Technical Service Information

FORD AX4N ENGINE STALLS IN ANY GEAR

Figure 1

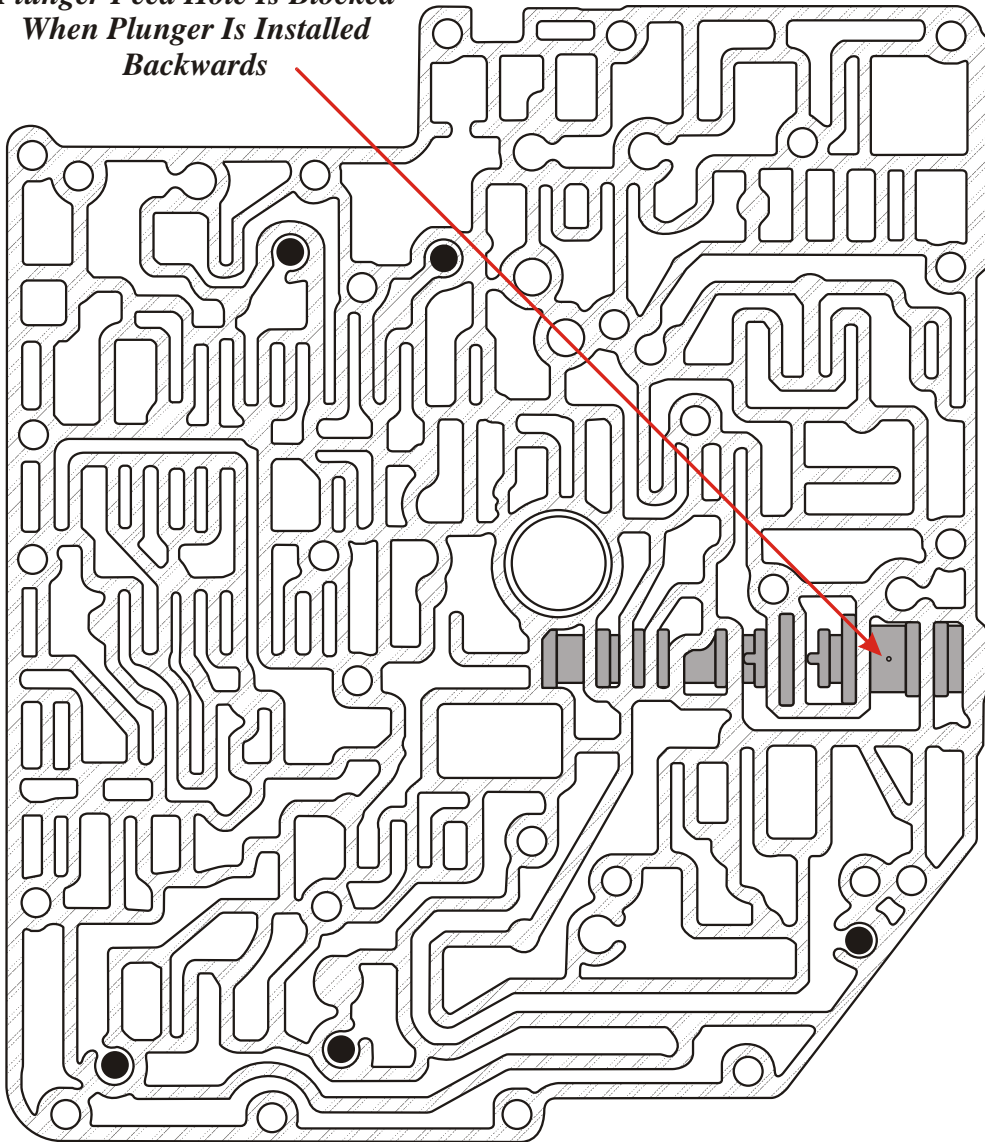
CAUSE: The cause may be, the Bypass Clutch Control Plunger, located in the bypass clutch control valve line-up has been installed backwards, *as it is shown backwards in most service manuals.*

When the spring and/or plunger are installed backwards, the plunger blocks the feed hole in the plunger sleeve, which in turn causes the balance of the valve to be lost, as shown in Figure 1. This allows the bypass clutch control valve to stroke to a position that will allow all converter clutch release oil to be exhausted. This of course will allow the converter clutch to be applied, and the engine will stall as soon as the manual shift lever is moved out of Park or Neutral.

*Plunger Feed Hole Is Blocked
When Plunger Is Installed
Backwards*

CORRECTION: Install the Bypass Clutch Control Valve, Plunger, Spring and Sleeve, as shown in the "*Correct*" illustrations in Figures 1 and 2.

Figure 2

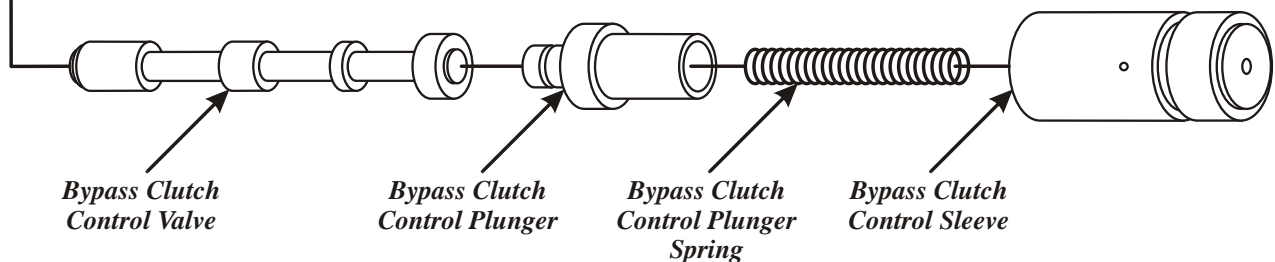
THIS IS "*CORRECT*" ASSEMBLY
